SERVICE BULLETIN

APPLICABILITY: 2013-14MY BRZ

NUMBER: 12-200-16R

SUBJECT: Rear Combination Lamp and Related
Enhancements

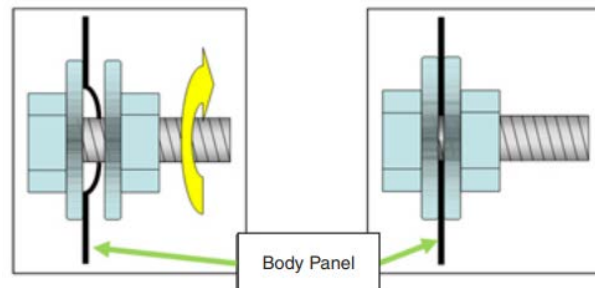
- Take out the 6 retaining clips from the trunk side liners then remove them to gain access to the combination lamp mounting nuts.
- After removing the 4 retaining nuts from each combination lamp, unplug and remove the assemblies.
- Before reinstalling any lamp assemblies, always inspect the rear body panel closely in the retaining nut areas for any deformation of the metal as shown in the illustrations below.

- If any deformation is found, **CAREFULLY** straighten the affected mounting area using a small body hammer and dolly.
- Another straightening method is to clamp the body panel using a bolt, flat washers and a nut as shown in the illustration below.

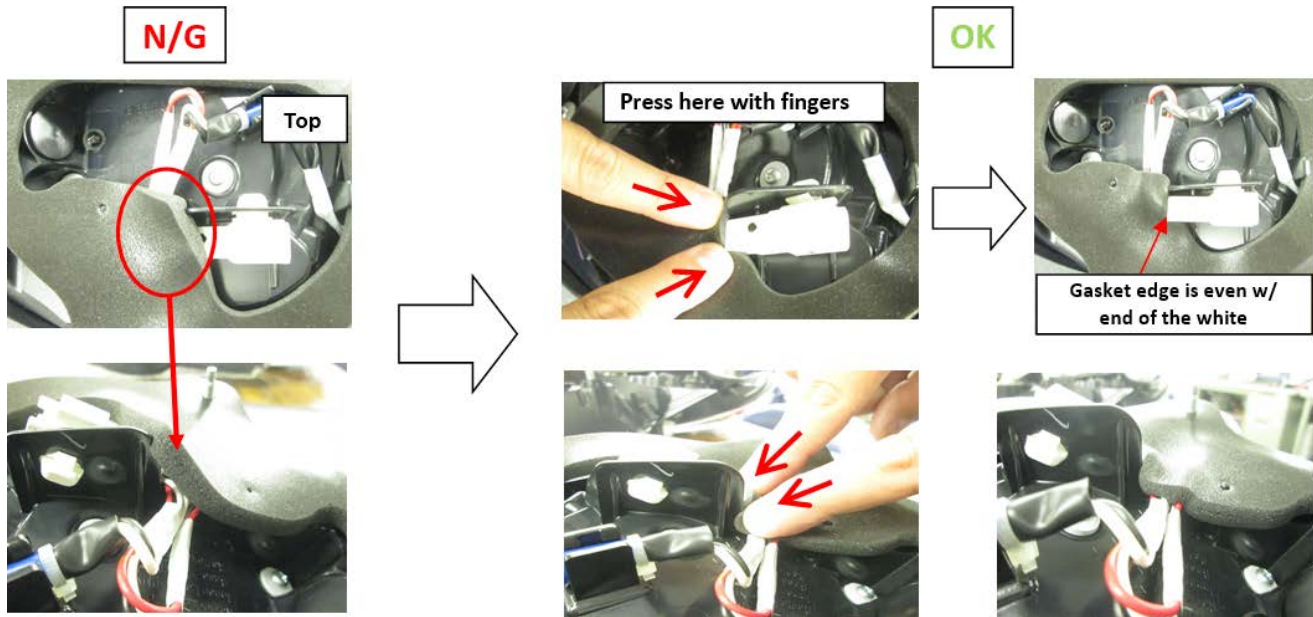
- Inspect the retaining stud boss areas of the housings for any cracking as shown below. If cracking is confirmed, the lamp assy. must be replaced.

NOTE: Unless the most recent combination lamp assemblies are already installed, when replacement is required, replace BOTH assemblies with the new parts.

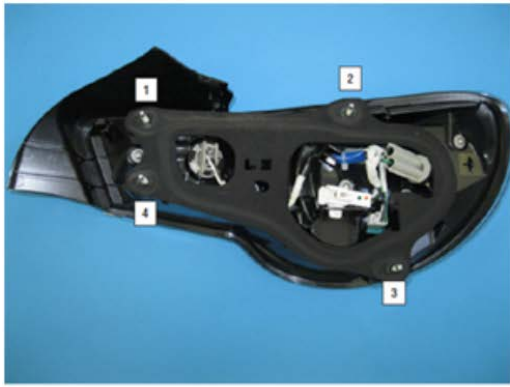
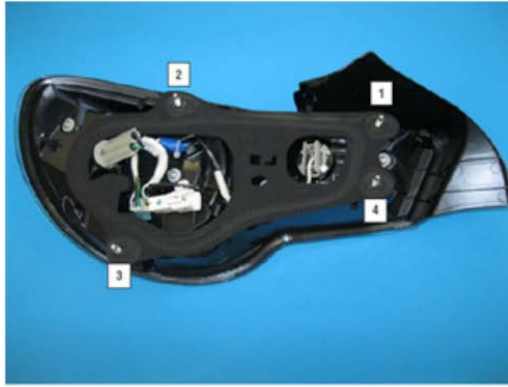
- The proper torque sequence must always be followed as shown in the photos below or damage to the combination lamp assembly may result. The torque specification for the retaining nuts is 4.5 Nm (39 inch-pounds).

Trunk Stopper

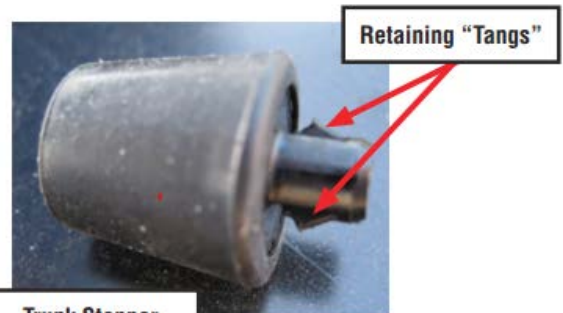
The photos below show the differences between the “OLD” and “NEW” trunk stoppers and the retaining tangs which secure them to the trunk lid.

- Flange surface dimension of retaining nuts increased from 12mm to 15mm.
- Thickness of the combination lamp gaskets increased for improved sealing.
- The “height” of the trunk stoppers has been increased by 2.7mm and a liner added to the trunk weatherstrip intended to improve crush resistance and keep the trunk lid from contacting (and in a small number of cases, cracking) the tops of the combination lamps when closing.
